# FORM-BASED ZONING REPORT

▶ <b>FILE #:</b>	<b>1-B-25-OB</b>	<b>AGENDA ITEM #:</b>	<b>42</b>
POSTPONEMENT(S):	1/9/2025	<b>AGENDA DATE:</b>	<b>2/13/2025</b>
▶ <b>APPLICANT:</b>	<b>HEYOH DESIGN &amp; DEVELOPMENT</b>		
OWNER(S):	Gordon & Stacy Savage		
TAX ID NUMBER:		109 A B 008	<a href="#">View map on KGIS</a>
JURISDICTION:		City Council District 1	
STREET ADDRESS:		515 MIMOSA AVE	
▶ <b>LOCATION:</b>	<b>North side of Mimosa, west of Atchley St</b>		
▶ <b>APPX. SIZE OF TRACT:</b>	<b>7166 square feet</b>		
SECTOR PLAN:		South City	
GROWTH POLICY PLAN:		N/A (Within City Limits)	
ACCESSIBILITY:		Access is via Mimosa Avenue, a local road with 24 ft of pavement width within a 38-ft wide right-of-way	
UTILITIES:		Water Source: Knoxville Utilities Board Sewer Source: Knoxville Utilities Board	
FIRE DISTRICT:		Knoxville Fire Department	
WATERSHED:		Tennessee River	
▶ <b>ZONING:</b>	<b>SW-3 (South Waterfront, Sevier Avenue)</b>		
▶ <b>EXISTING LAND USE:</b>	<b>Single Family Residential</b>

## **Zoning Administrator Report for Level III: Alternative Compliance Review**

**515 Mimosa Avenue**

SHEET  
A101  
5 OF 12  
GROUND FLOOR  
PLANS

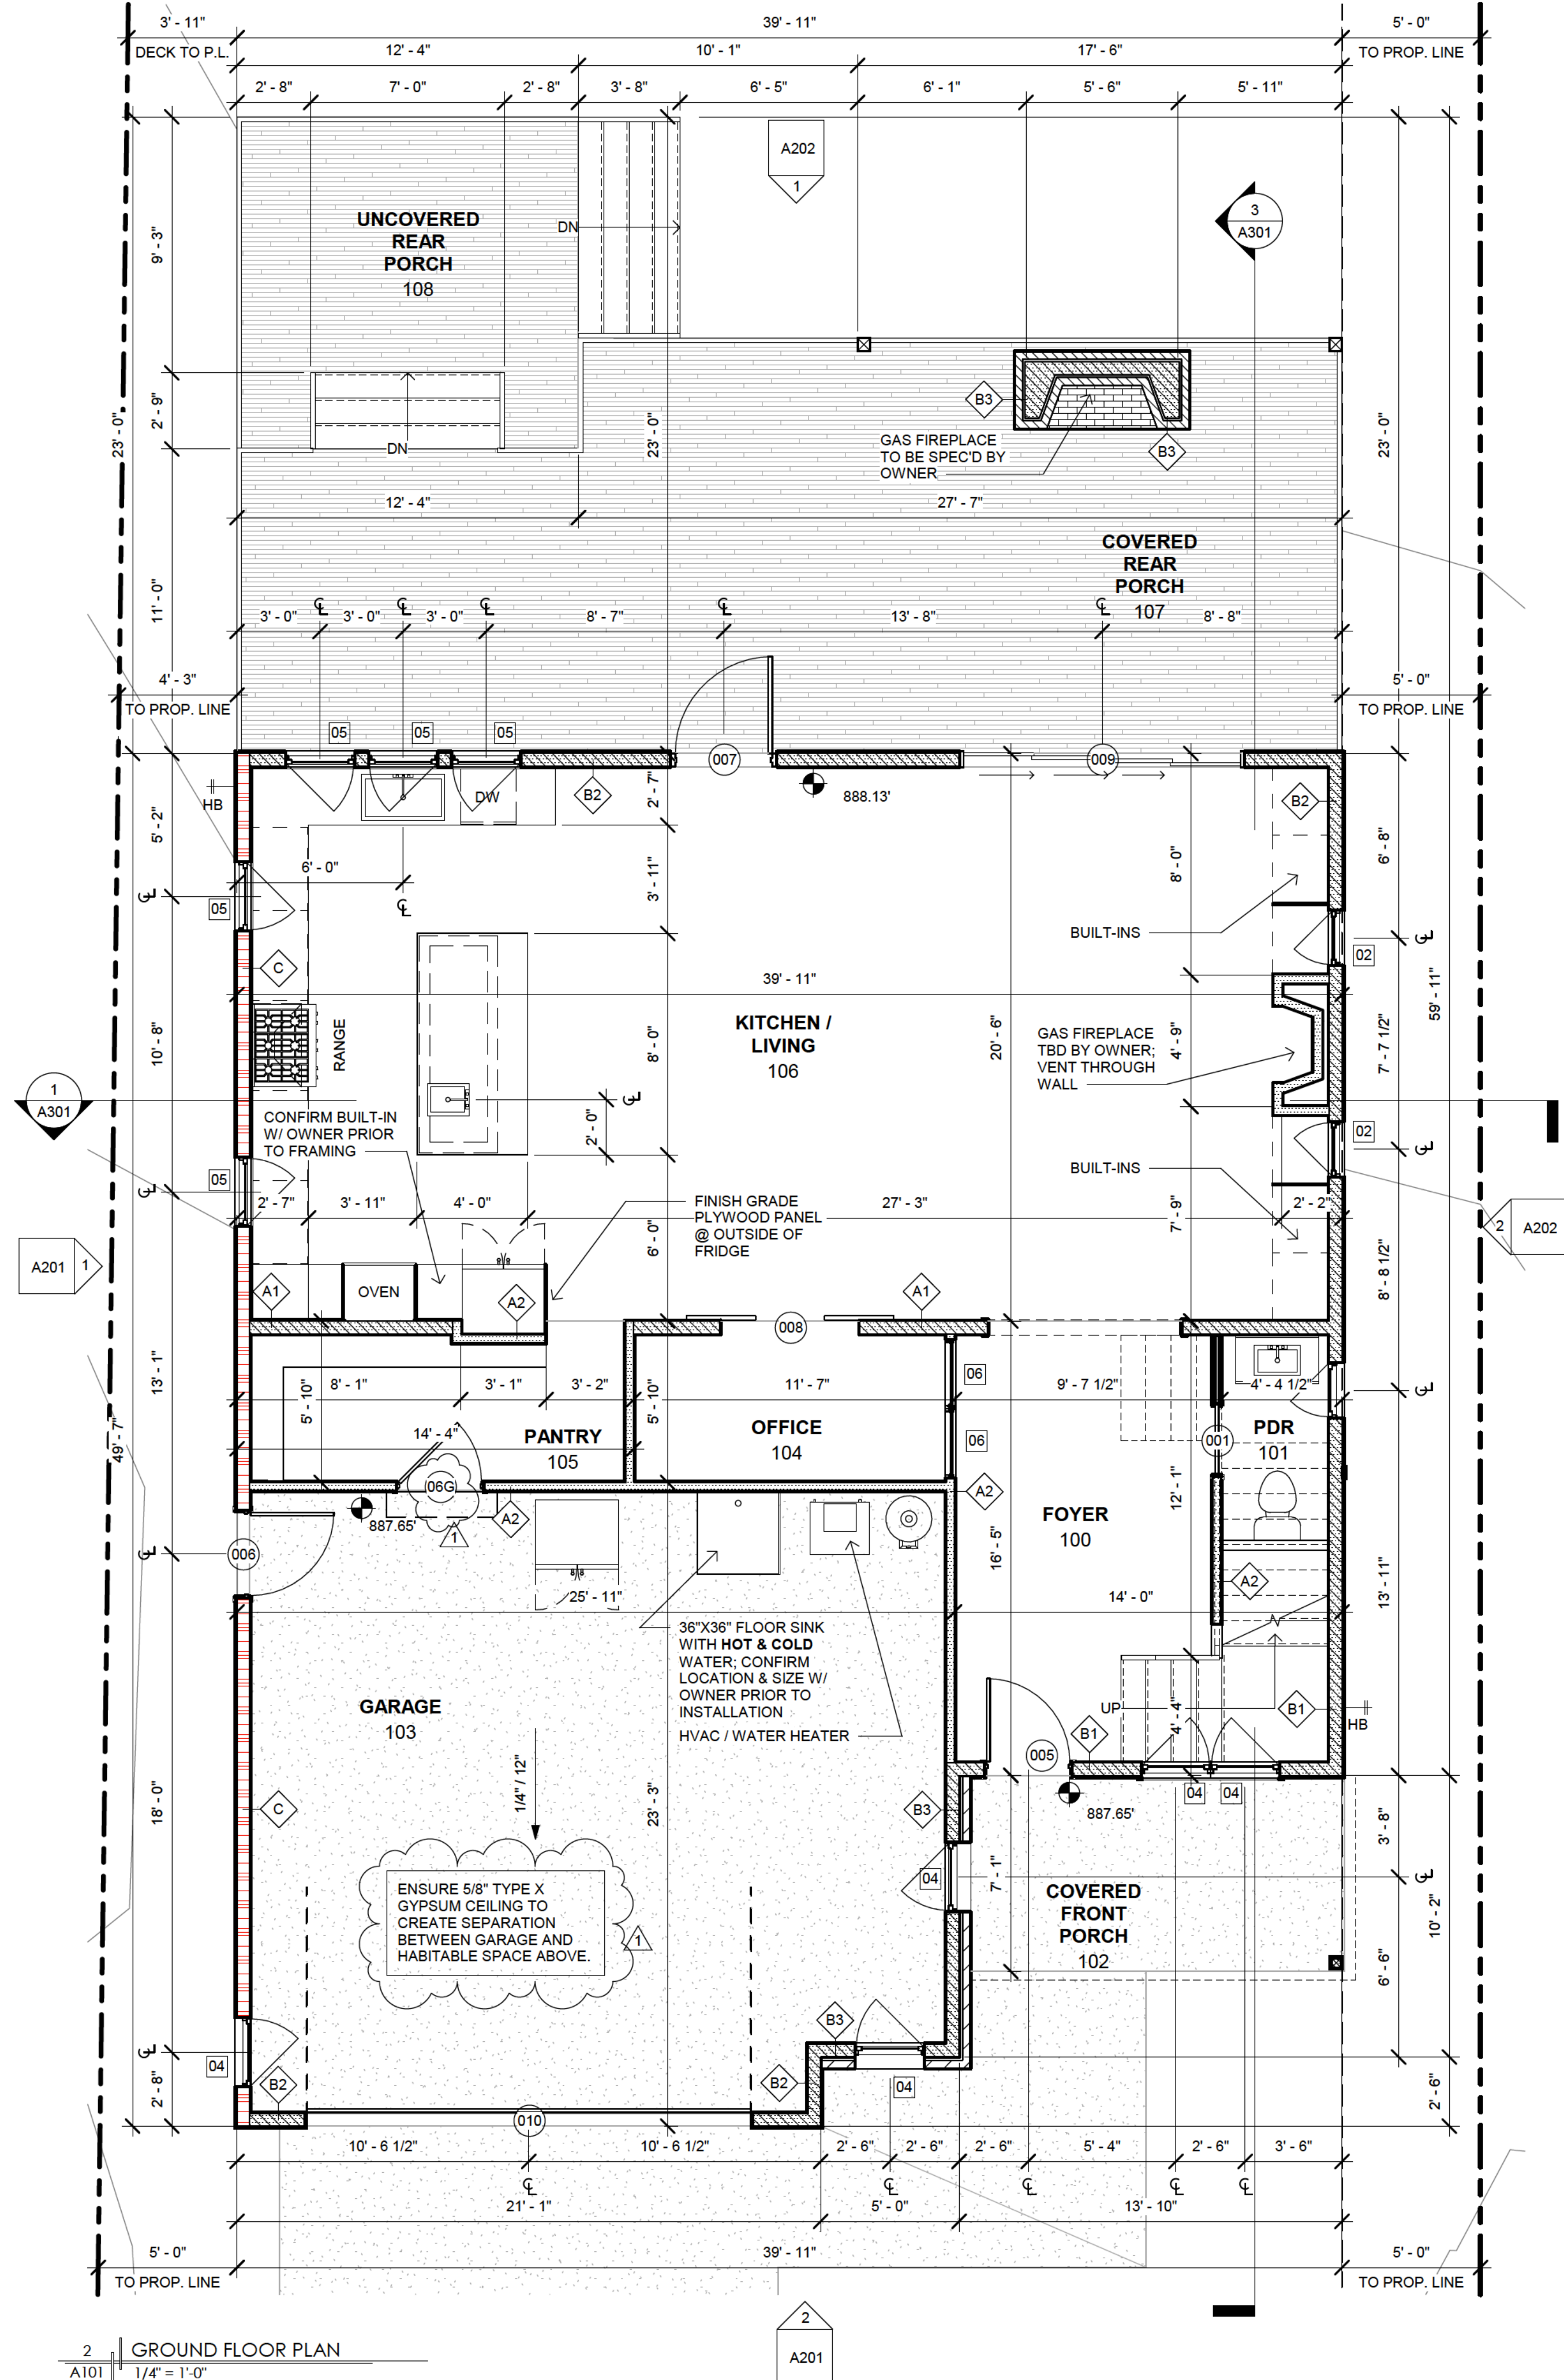
- Article 7.1.3.D.7.d – Garage Location – to rear of property or underneath building.
- Article 7.1.3.D.7.c - Surface parking / vehicular use area must be 65% permeable. Please provide permeable surface and provide calculations on the plans showing that 65% (minimum) of uncovered surface parking is permeable. Calculations and permeable surface for parking / vehicular use area only apply within the property lines.
- Article 7.1.3.D.2.b - Label the highlighted contours. It is believed that contours range from 888’ to 892’. If so, there is insufficient slope for the proposed grade change from

existing contours to the FFE's to divert water around the home and keep slopes that do not exceed 2:1 (H:V). Retaining walls may be required.

- The maximum allowed driveway slope is 15%. The existing contour at the road near the driveway entrance is believed to be ~ 892'. The estimated slope to the projected elevation at the back of the sidewalk to the garage FFE of 886.96' greatly exceeds 15% and may not be functional for vehicles.
- When a driveway is proposed through an area with sidewalk, show the sidewalk to continue through the driveway and show lowered 6" detached lowered curbing at the interface of the apron and roadway.

SHEET
<b>A201</b>
7 OF 12
ELEVATIONS

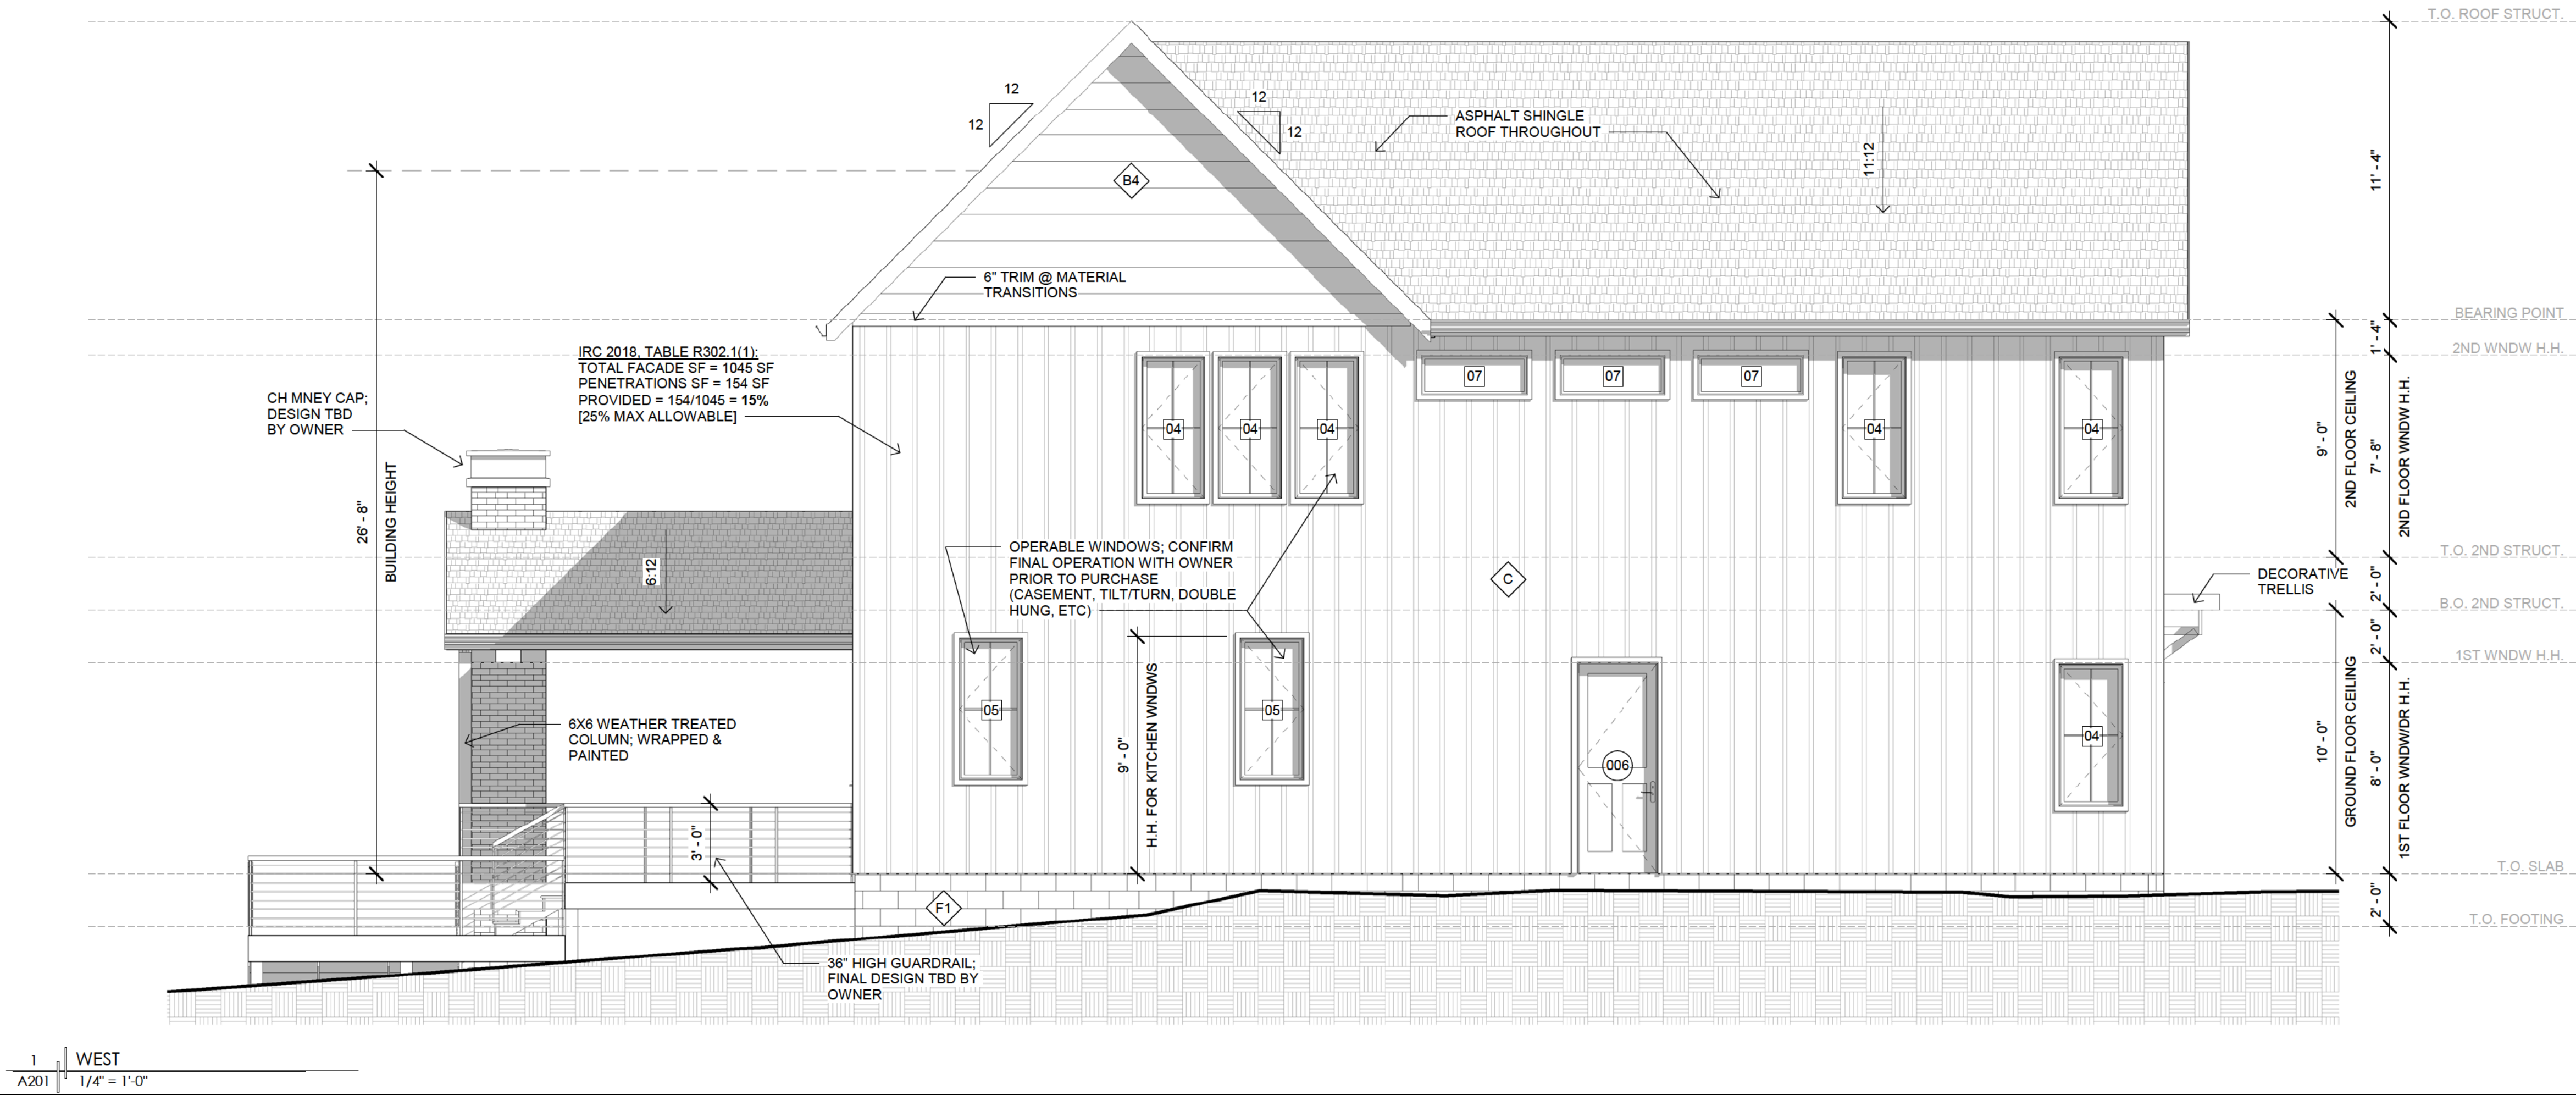
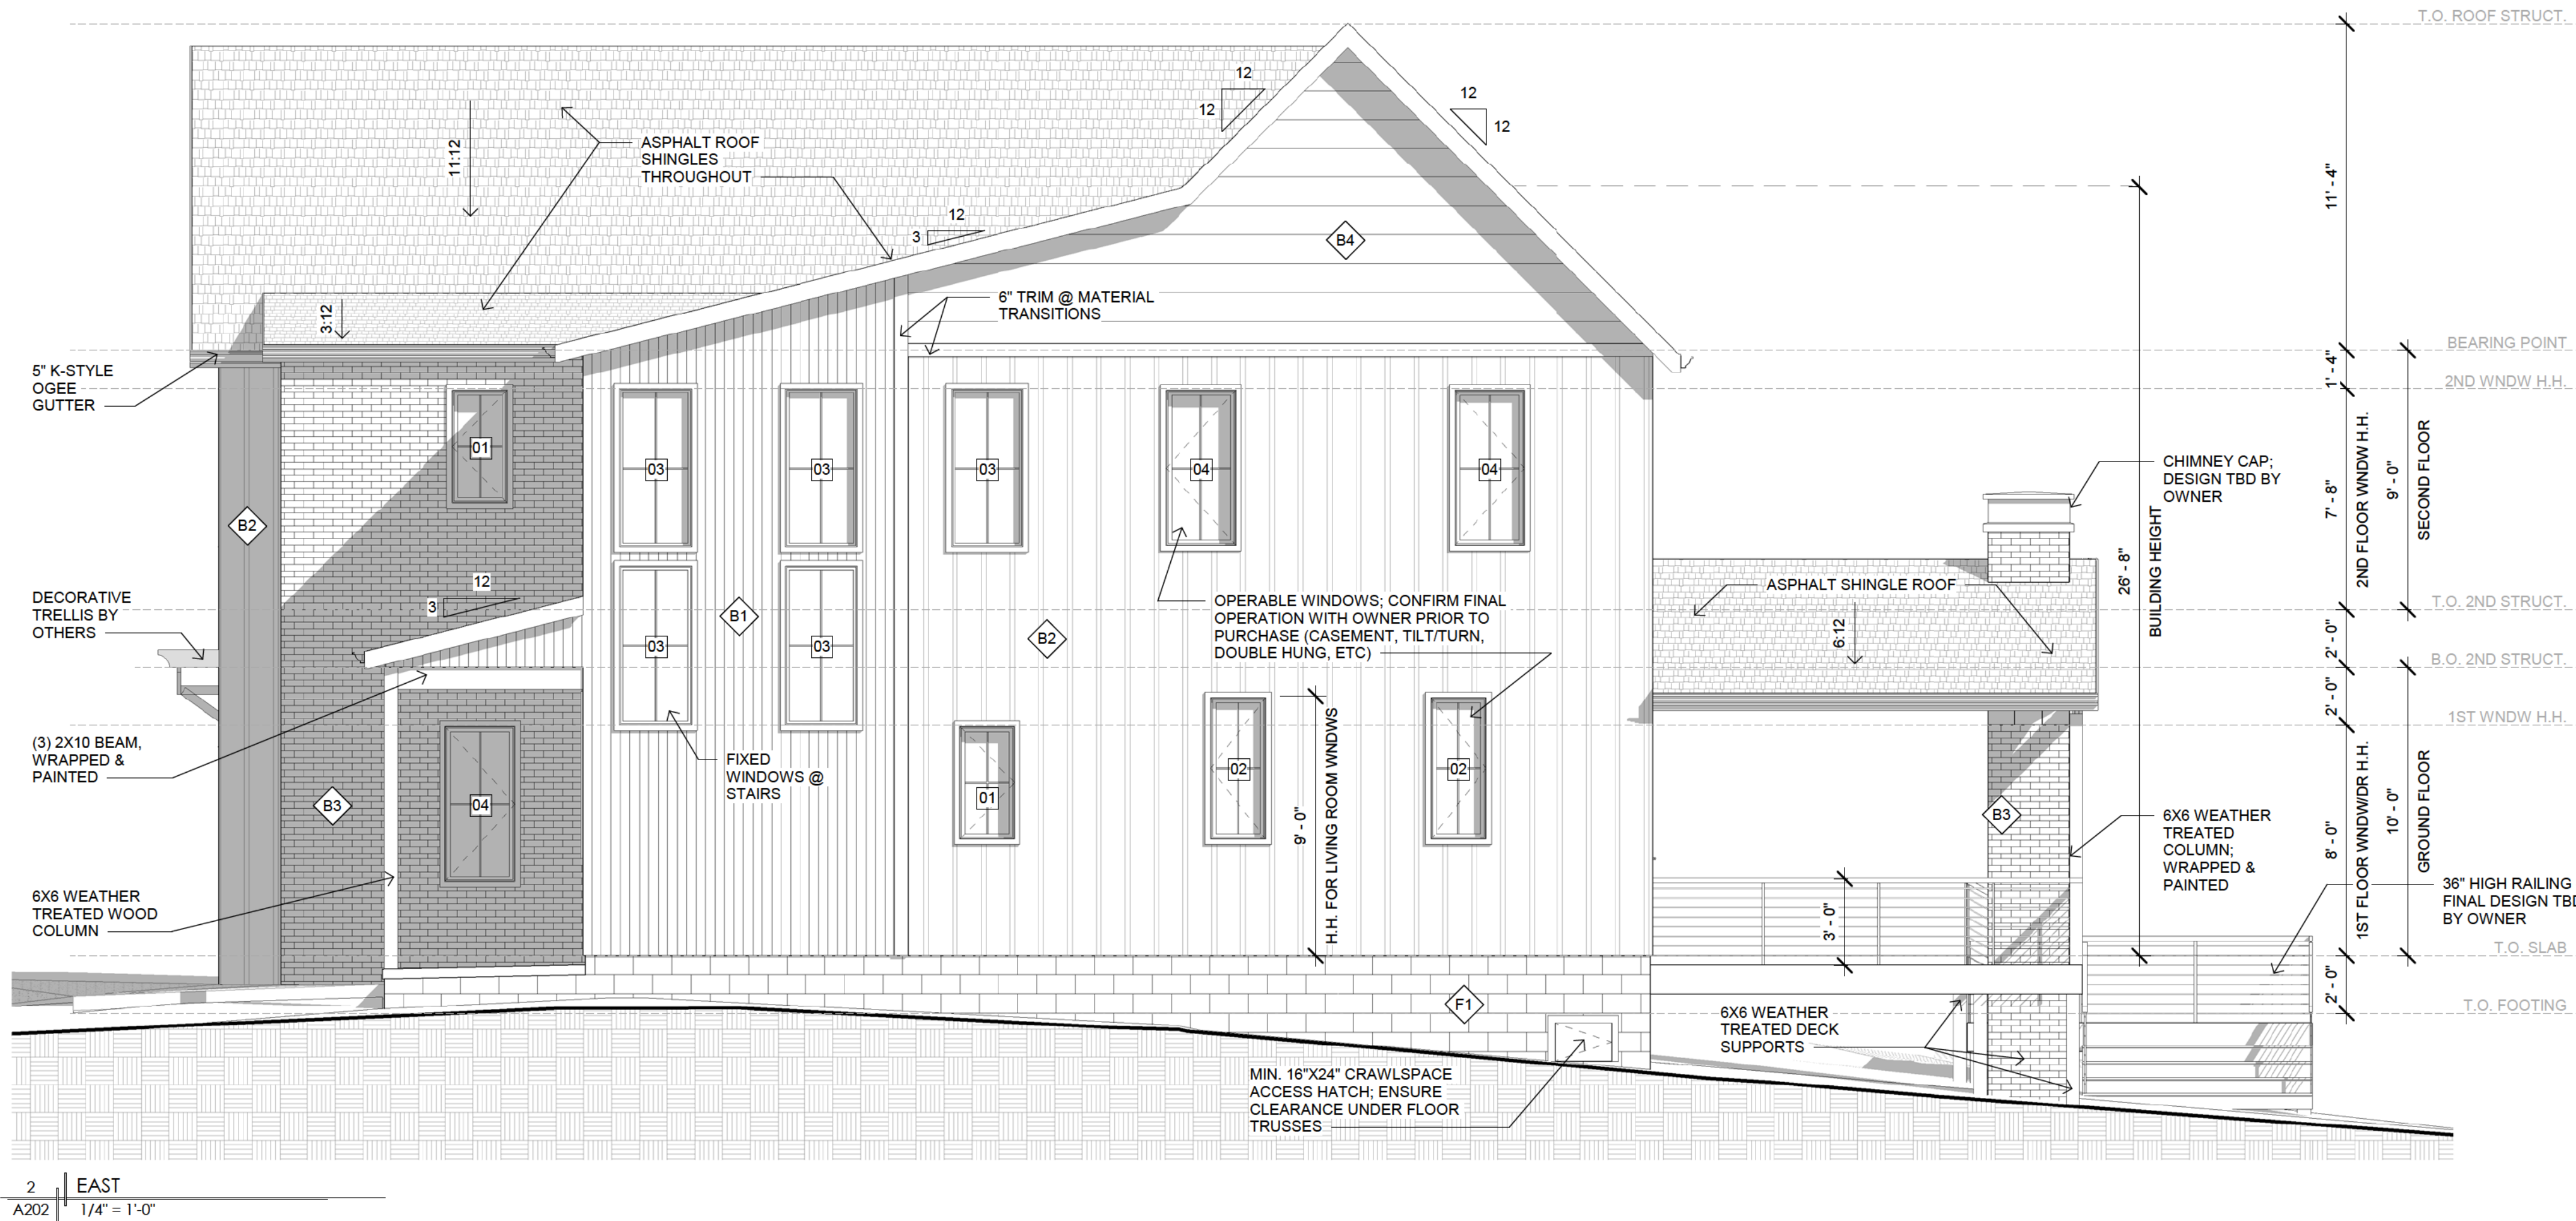
The strict interpretation of the SW-3 form based code does not allow garages to be located at the front of the property. Additionally, a reduction from the required 70% to 12.4% transparency calculation on the front façade qualifies as a Level III review because Article 7.0.2.F.8.c.i states, “No variance can be granted to reduce transparency by more than 10% in the South Waterfront District.”

The applicant is continuously working with the Administrative Review Committee to address unresolved comments. The location of the garage is not in an approved location and the level of transparency reduction cannot go through the variance process. Due to topography, the applicant has suggested they cannot utilize the rear alley to locate the garage to the rear of or underneath the dwelling and that a garage located at the front of the dwelling is the best solution to provide covered and secured off-street parking. It should be noted that parking is not required in the South Waterfront District.
